1 Common Questions and Corresponding Answers

Reviewer 1

Figure 1: Uncoded throughputs (old versions left, new versions right).

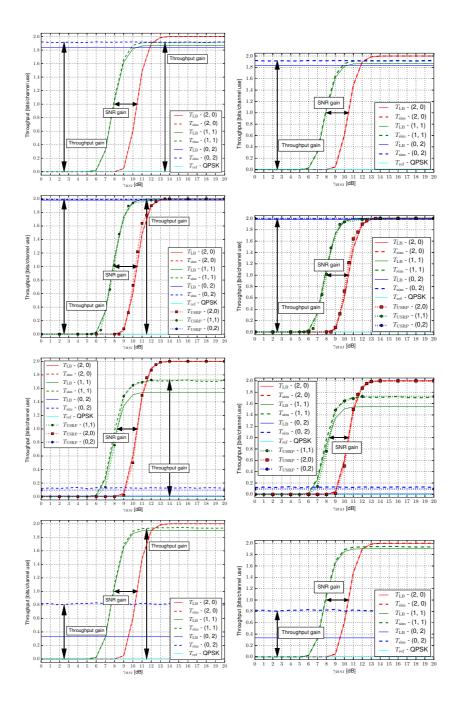
- Q: In figure 6, 7, 8, 9, the reference scheme using QPSK always has a zero throughput, which demonstrates that this reference modulation scheme does not work at all in WBN under the proposed SNRs. Then the proposed communication scheme is claimed to have performance enhancement for sure. However, logically, this only demonstrates that the proposed algorithm gives positive throughput in WBN instead of not working. But it is not enough to say it gives a "performance enhancement" comparing with a previous working scheme. So it would be better if the author can further compare some other modulation schemes which can also give some positive throughput in WBN.

- A: See A2. Considering the two time slot communication, there is indeed no state of the art solution for joint decoding, that is the constellation design in sources such that the relay would reliably jointly resolve data¹ from both sources. We thus decided to claim the performance of the proposed N_b = 0, N_s = 2 compared to the zero throughput QPSK as the throughput gain. Nevertheless, the reviewer has point that it is unfair to claim the performance of the proposed N_b = 1, N_s = 1 constellation as throughput gain compared to zero-throughput QPSK, because a conventional wireless network coding with BPSK would give a nonzero throughput in this case. We therefore drop this claim from our Figures 6-9 in manuscript (check Figure 1).
